# PREVIOUS FLIGHT ANOMALIES BACKUP

# POST STS-107 FIRST FLIGHT CONFIGURATION CHANGES

# MCR 19755 ORBITER BOOM SENSOR SYSTEM (OBSS)

## MCR 23278 SSOR & WVS UHF Antenna Relocation

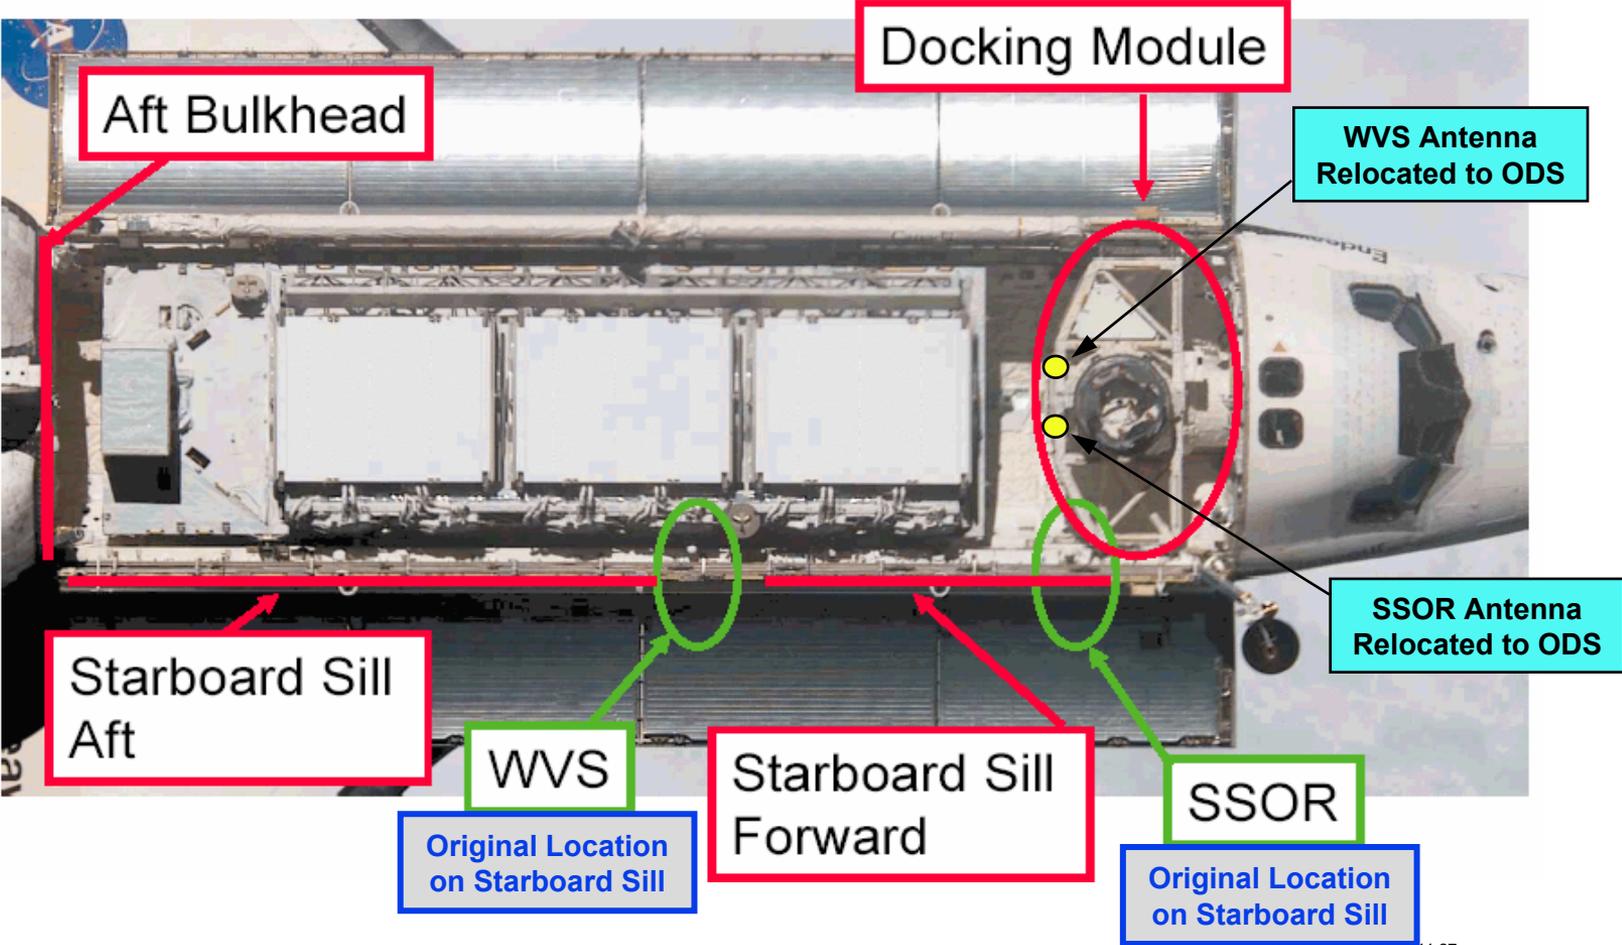
- Relocates the SSOR and WVS UHF antennas from their original payload bay starboard sill location to the aft, upper ODS truss
  - Required to remove interferences for mounting locations on the starboard sill for installation of the inspection boom and MPMs
- Modification involves -
  - New coax cables / mounting clips for rerouting of the associated antenna power and coax cables
  - New antenna mount brackets for the new antenna location
  - TCS blanket changes

# MCR 19758 WING LEADING EDGE MICRO-TAU INSTRUMENTATION

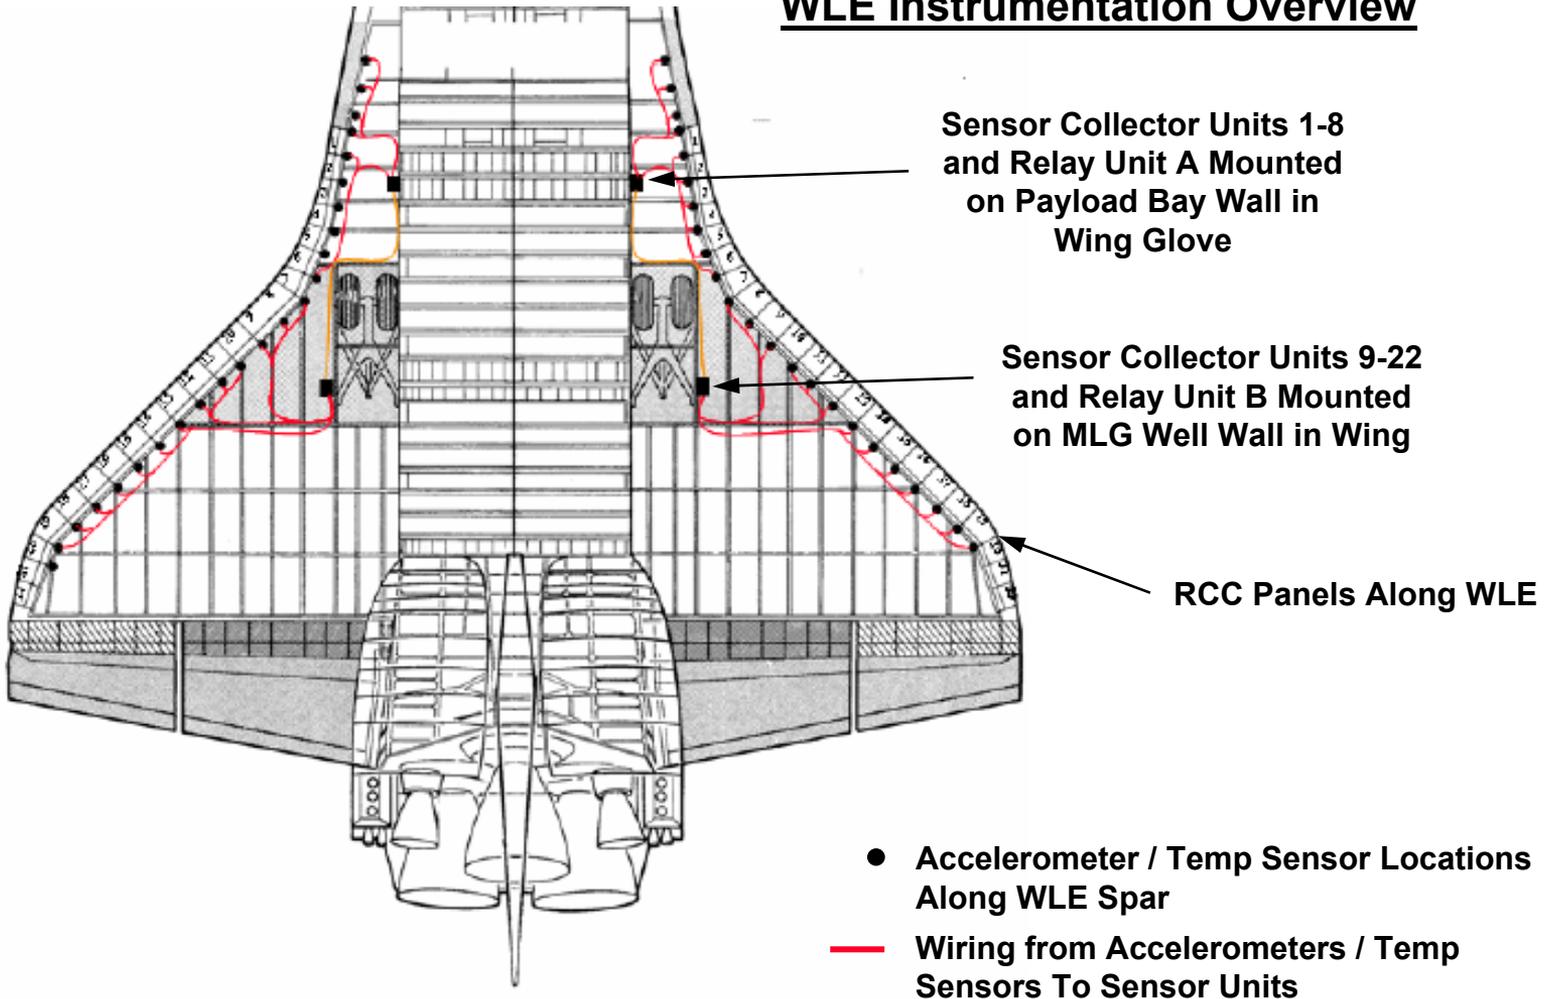
- Installs 66 accelerometer and 22 thermal measurements in the wing leading edge area of each wing with wiring to crew compartment panel interface for capability of capturing instrumentation data
- The instrumentation provides an impact detection system, used primarily for ascent monitoring with some MMOD/on-orbit capability
  - Serves as means to help identify and narrow areas for inspection to complement visual inspection capabilities
  - Data is collected and communicated to ground via PGSC/laptop computer
- The sensor instrumentation, certification and functionality is NASA GFE responsibility
- Boeing has responsibility for installation engineering and installation certification
  - AFD, PLB, wing installation of GFE sensors, mounting structure, wire harnesses and flight deck A13 panel modification

# MCR 23288 ET UMBILICAL DIGITAL CAMERA

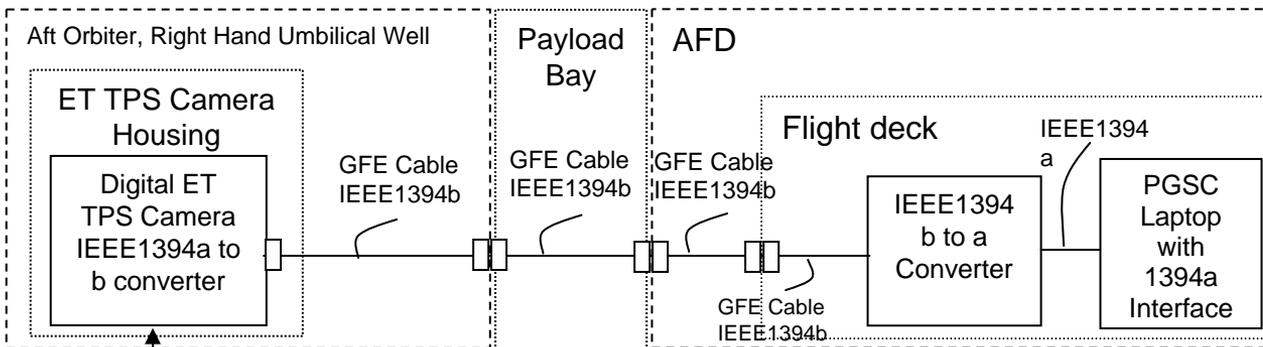
- Incorporates new GFE LO2 external tank (ET) umbilical well digital still camera and harnesses to crew compartment panel interface
- Provides functionality to capture and downlink high resolution ET sep photo images
- Camera is a direct replacement for existing still camera and will use existing Shuttle interfaces and power services
- NASA responsibility for camera and 'fire wire' cable hardware, certification & functionality
- Boeing responsibility for hardware installation engineering and installation certification
- Implements CAIB return to flight recommendation to provide capability to obtain and downlink high resolution images of the External Tank (ET) after separation - existing camera film imagery of the external tank can only be recovered after end of mission

## MCR 19763 WLE "HORSECOLLAR" GAP FILLER REDESIGN

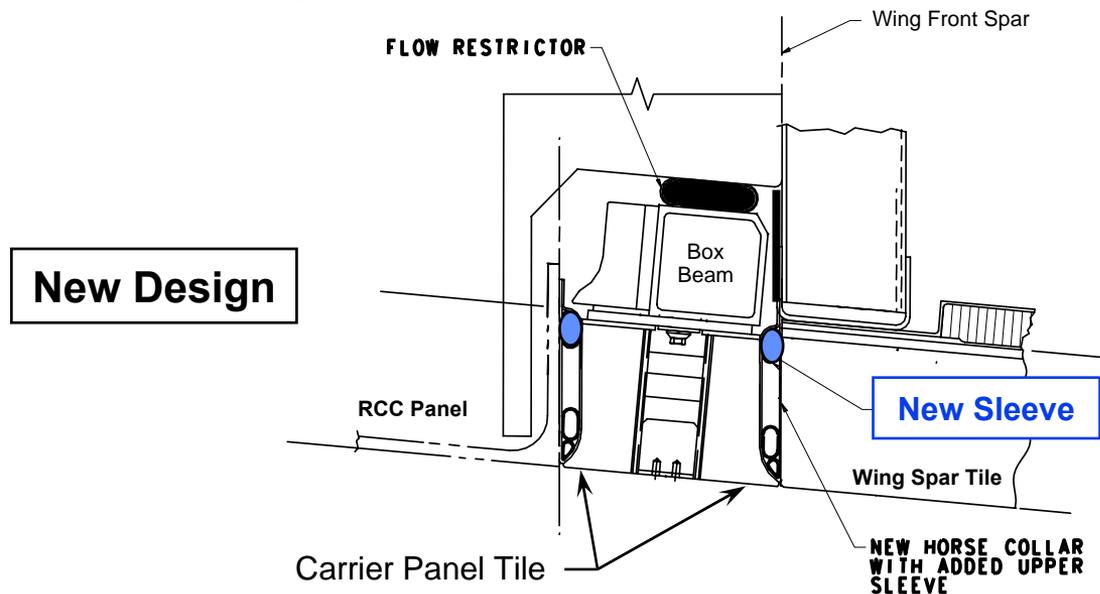
- Horsecollar Gap Filler redesigned to add additional 0.50 DIA sleeving at IML end of the horsecollar
  - Existing horsecollar has two sleeves at OML
  - New design adds additional sealing capability in the event of partial tile loss, preventing early ingestion of flow into LESS lower spar
- Utilizes existing certified Nextel fabrics

# FORWARD ATTACH ARROWHEAD TILE REDESIGN

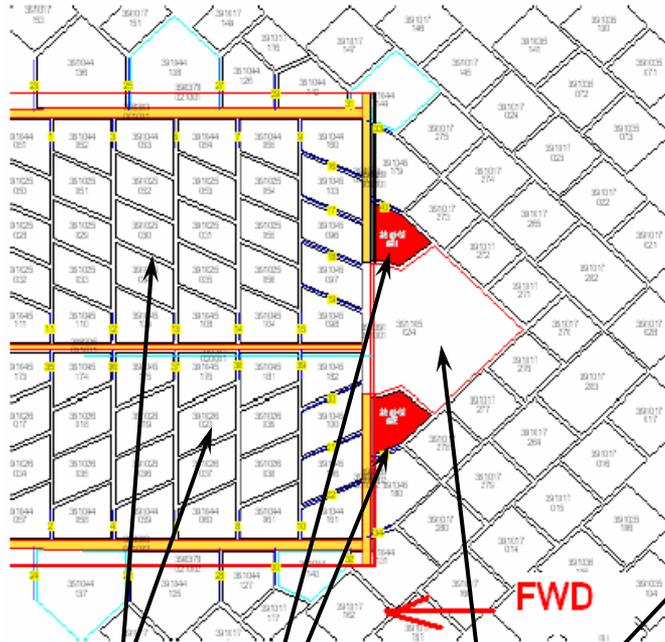
- Design changes to eliminate potential of in-plane cracking of two tiles which interface with both the arrowhead and the NLG door thermal barrier
  - These tiles were found cracked during inspection of OV-103 and OV-104 after tiles had been removed, following removal of the NLG door thermal barrier and gap fillers
    - Cracks found at densification layer of the tile, emanating from a filler bar relief cut in on the arrowhead side of the tile - drawing does not specify relief cuts
    - These two tiles have a dynamic interface to both the NLG door thermal barrier and the ET attach arrowhead, which subjects the tile to pyro shock load at ET separation
      - Pyro shock loading not considered in original certifications
  - Inspection of OV-105 tiles showed they did not have the relief cuts nor cracks (19 flights)

## Electrical Bracket Modification at Shoulder MPM

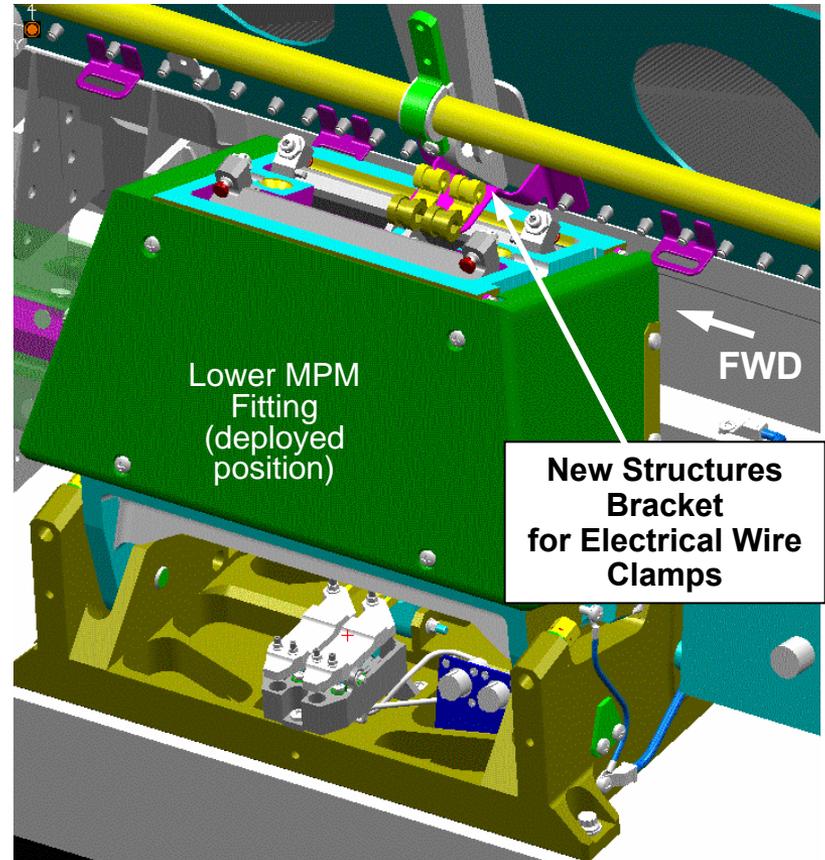
Electrical Bracket Interference @ Shoulder MPMs (Xo679.5 LH 7 RH)

Interference Eliminated with Redesigned Bracket

# MCR 23405 PAYLOAD BAY MPM CONTINGENCY INTERFERENCE MODIFICATION

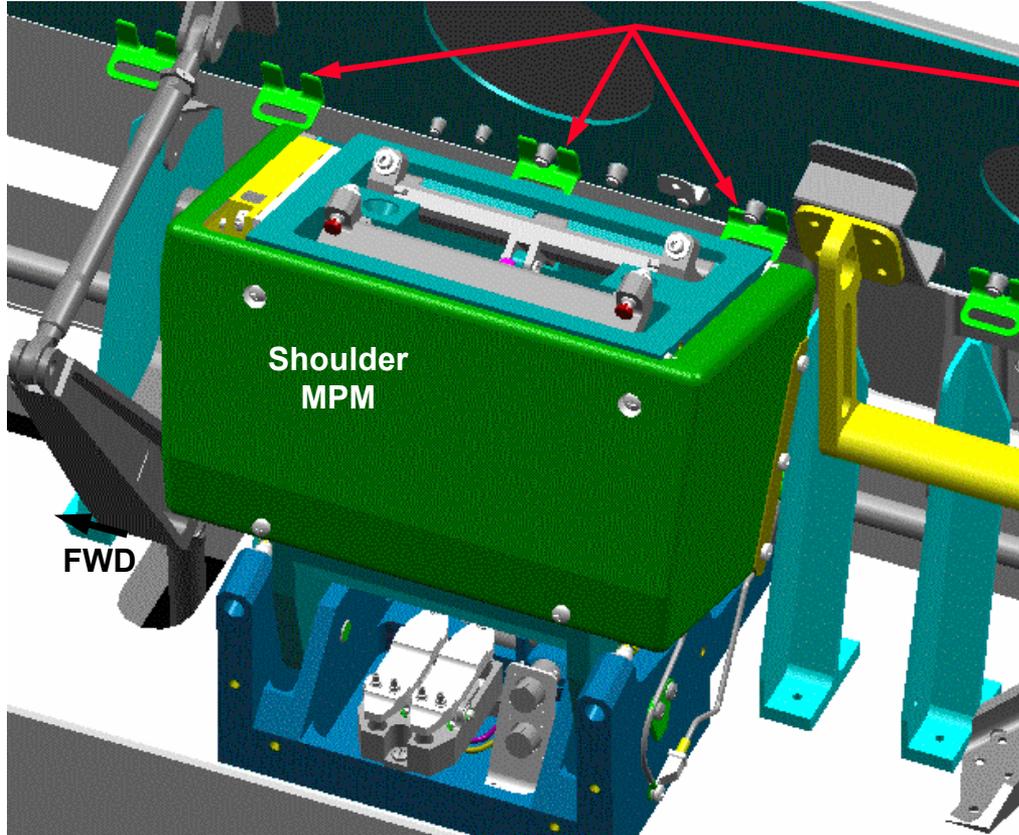
- The TCS blanket clips create an interference problem at all MPM locations
  - 4 MPM locations LH (RMS) side - 10 clips total
  - 3 MPM locations RH (OBSS) side - 7 clips total
- Mod corrects these interferences by rotating the clips 180° to relocate - total of 13 clips LH side and a total of 9 RH clips
  - 5 additional clip relocations required to accommodate associated TCS blanket redesign
  - An associated 9 TCS blankets are modified to attach to the new clip locations

## MCR 19832 Payload Bay MPM Contingency Interference Mod (PLB Door Handrails)

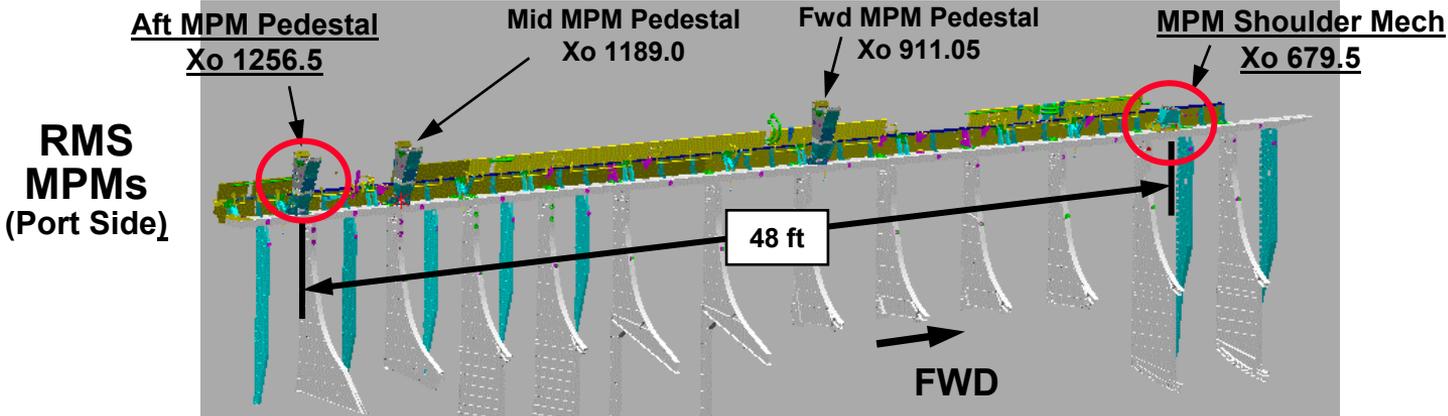
- Design change to eliminate the potential interference of payload bay door (PLBD) EVA handrails and attach fittings during a contingency MPM jettison scenario
- Contingency Scenario
  - MPM system mechanical jam failure in deployed position requiring the OBSS or RMS and upper MPMs to be jettisoned to allow PLBD closure
  - Interference occurs between remaining lower MPMs and the PLBD handrails and attach fittings when PLBD's are driven closed
    - Interference exists at two locations per side – at the shoulder MPM (fwd location at Xo 679.5) and the aft MPM pedestal (location Xo 1256.5)
- Modifications implemented to eliminate interferences
  - Forward shoulder location – redesigns the end fitting of the handrail to clear the MPM
  - Aft pedestal location - removes a short section of the EVA handrail and trims the associated handrail attach fitting on the payload bay door

# MCR 23140 PYRO COMMAND REDUNDANCY

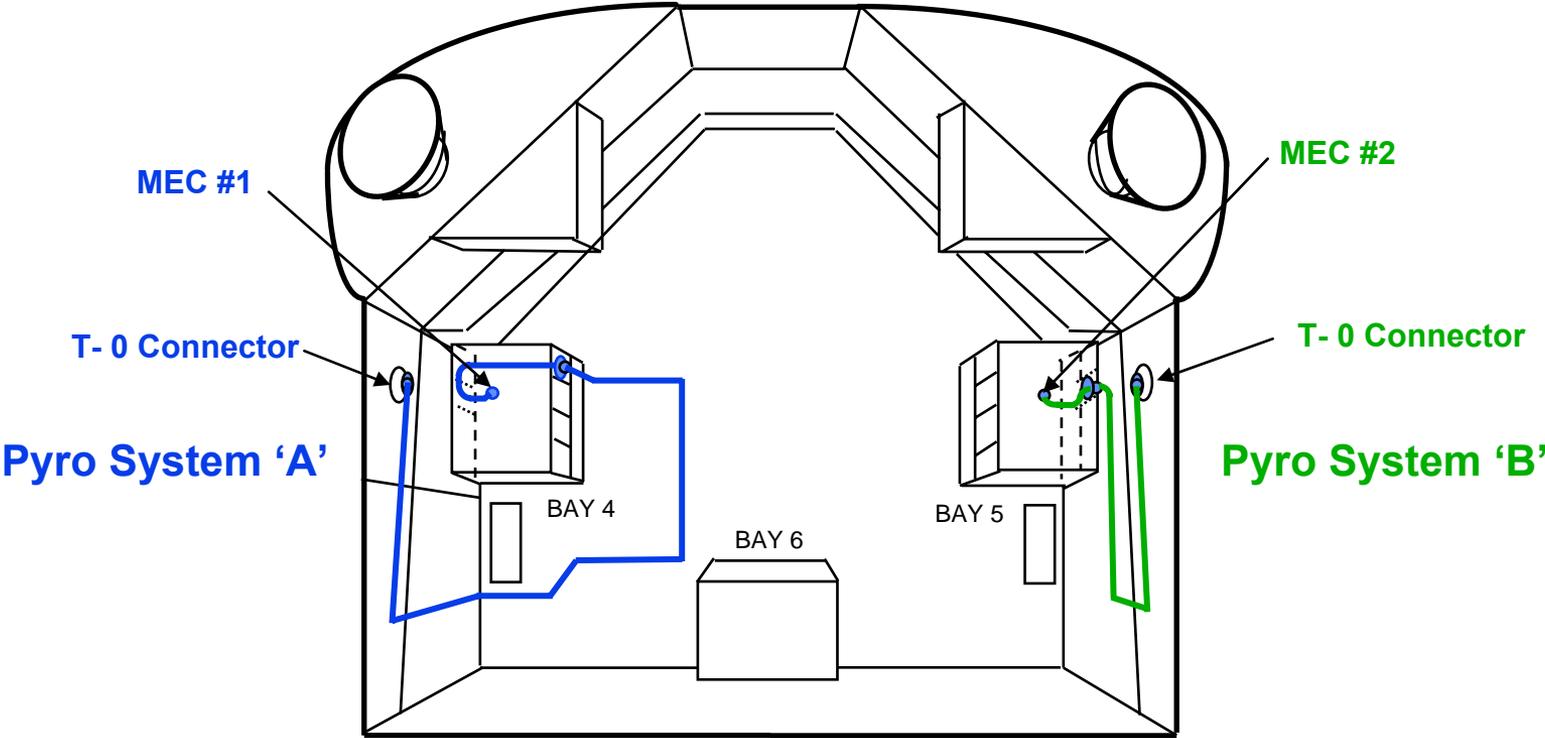
- During STS-112 the SRB Hold Down Post (HDP) and ET Vent Arm System (ETVAS) System 'A' pyrotechnics did not detonate due to the lack of receipt of a Fire command
  - The fully redundant System 'B' operated nominally
- A formal investigation team identified an open circuit in the Fire command path at the LH<sub>2</sub> T-0 umbilical as the most probable cause of the anomaly
  - Corrective actions addressed the most likely cause of the anomaly at the T-0 interface
- Further action was pursued to investigate introduction of additional command redundancy through *each* T-0
- To provide additional redundancy for these functions, the Orbiter Pyro Command Redundancy modification provides redundant copper paths through both T-0 umbilical interfaces
- The ground will comparably institute full copper path redundancy from the T-0 interface into the PIC Rack

# MCR 23227 CONNECTOR SAVER REDESIGN

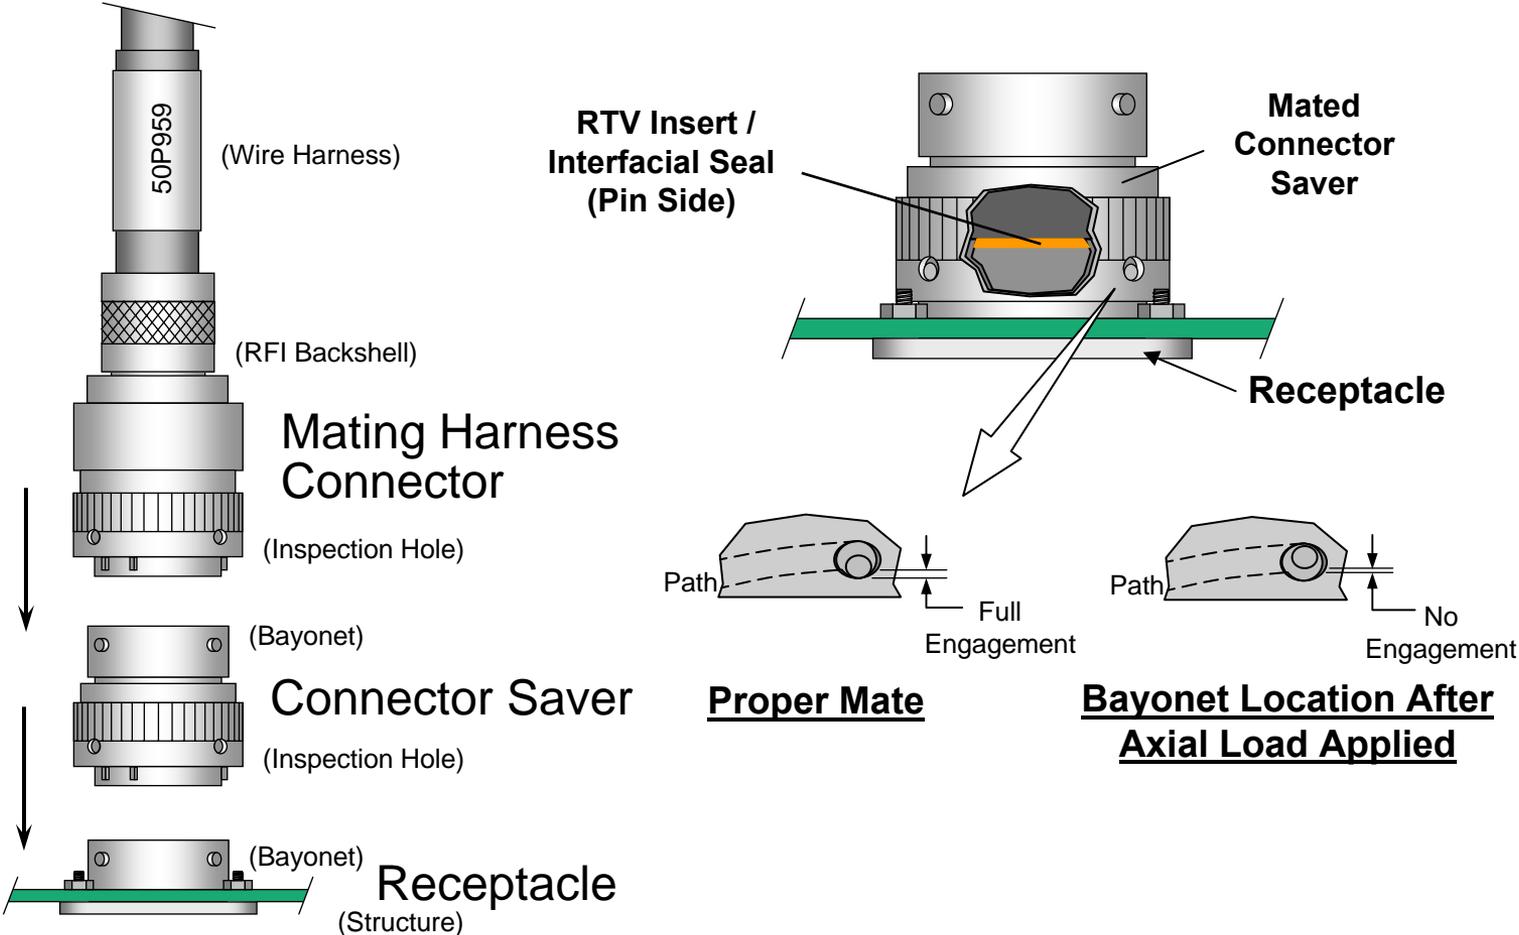
- Necessitated interim corrective actions on existing hardware to ensure proper harness mates
  - Connector savers were either removed, or inspected for proper bayonet engagement and then safety wired or taped
